Office Action Summary

10/828,434

1. Restriction to one of the following inventions is required under 35 U.S.C. 121:
 - I. Claims 1-12 and 18-21, drawn to a ridge vent, classified in class 52, subclass 198.
 - II. Claims 13-17, drawn to a method of manually separating a ridge vent, classified in class 52, subclass 745.16.

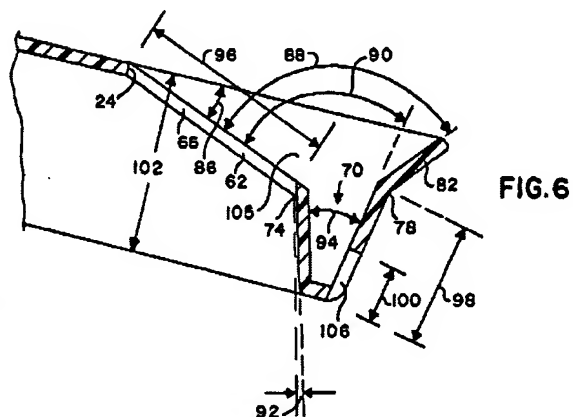
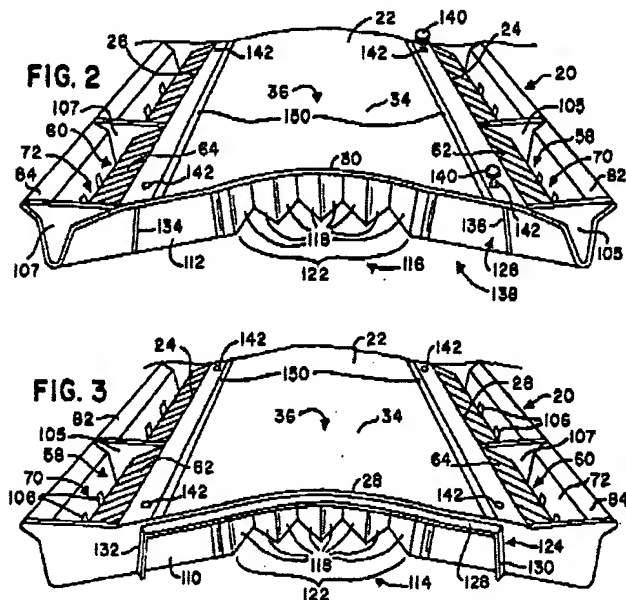
a. Claim 1. Smith discloses a ridge vent with an elongated flexible top panel (Column 2 Line 58) having a central portion 36 and edges 24 & 26 (Smith Fig. 2), wind baffles 82 & 84 defining an opening between the central section edges 24 & 26 and the baffles (See Figs. 2,3, & 6), and a plurality of ribs 66 spanning said openings between the edges and baffles. Morris discloses a ridge vent with at least one score line, disclosed as a "cut line" (Figs. 3 & 4 below, Ref. 24), extending across the top panel to "facilitate manual separation" along the line (Column 3 Line 9). The Morris score line is such because it is a notch, scratch, or incision, specifically a cut or perforation in the material. A score line is generally added because it allows an installer to easily and efficiently segment a ridge vent segment to a desired length. Thus, it would have been obvious to one having ordinary skill in the art, at the time the invention was made, to have modified the Smith ridge vent with the score line taught by Morris because it allows an installer to easily and efficiently segment a ridge vent segment to a desired length.

FIG. 3

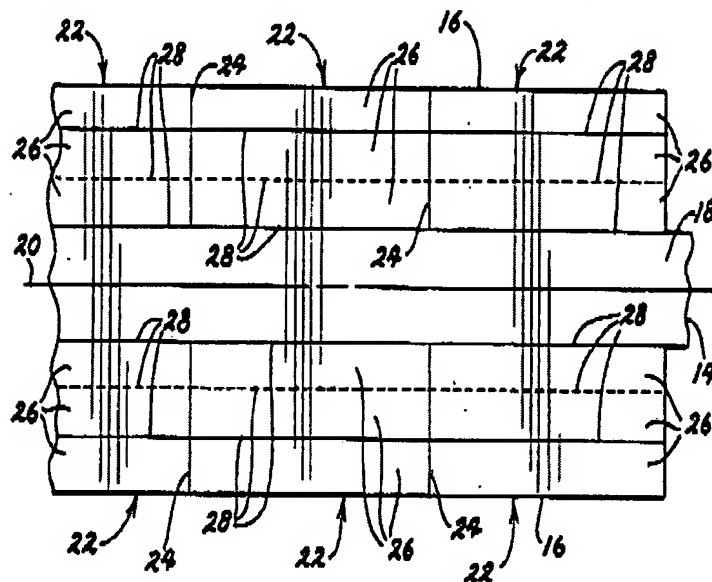
- b. Claim 2. The Smith/Morris combination discloses a plurality of score lines, referred to as "cut lines", 24 extending across the top panel 18 at spaced intervals in that each pair of segmented portions 22 are separated by a cut line resulting in a spaced plurality (Figs. Above).

h. Claim 10. The Smith/Morris combination discloses all the elements of the invention including wherein the aligned cutting guide is formed in each wind baffle. The Smith/Morris combination discloses a cut line "extending entirely through the blank," (Morris Column 3 Line 11, See also Figs. 3 & 4).

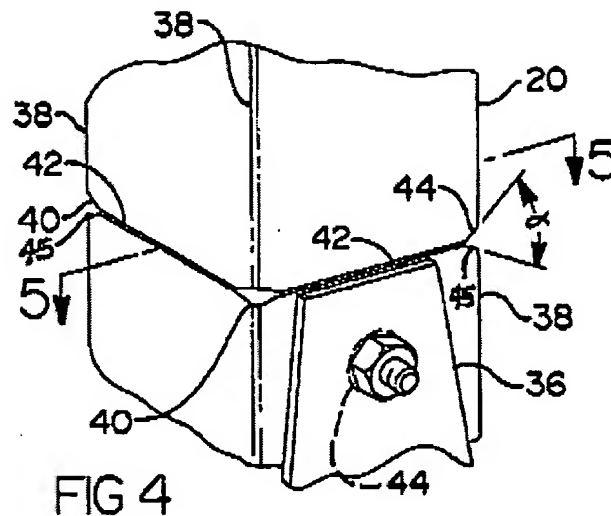
j. Claim 5. The Smith/Morris combination teaches all the features of the invention except the vent further comprising a bending notch formed in at least one edge of the score line. Hillstrom teaches it is well known in the art to include notches 40 at the end of a score line 42 to provide an area of stress concentration that facilitates fracturing (See Hillstrom Column 6 ¶ 1). Thus, it would have been obvious to one having ordinary skill in the art, at the time the invention was made, to have modified the Smith/Morris combination with a notch formed in at least one edge of the score line as taught by Hillstrom to provide an area of stress concentration that facilitates fracturing.

k. Claim 6. The Smith/Morris combination teaches all the features of the invention except the vent further comprising a pair of bending notches formed at either end of the score line. Hillstrom teaches it is well known in the art to include notches 40 at either end of a score line 42 to provide an area of stress concentration that facilitates fracturing (See Hillstrom Column 6 ¶ 1). Thus, it would have been obvious to one having ordinary skill in the art, at the time the
